# A PCN 09\_0196 CHANGE OF Q COMPLIANCE INDICATOR FOR JM38510 MODELS

### Comparison of Top Mark

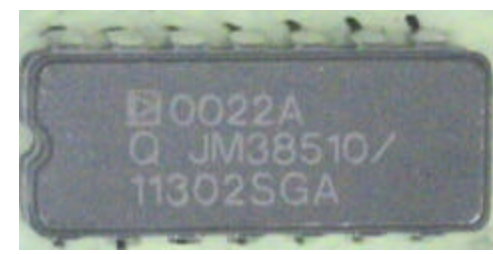
**Current Top Mark Format  
(Without Space between Q and JM38510)**

**New Top Mark Format  
(With Space between Q and JM38510)**
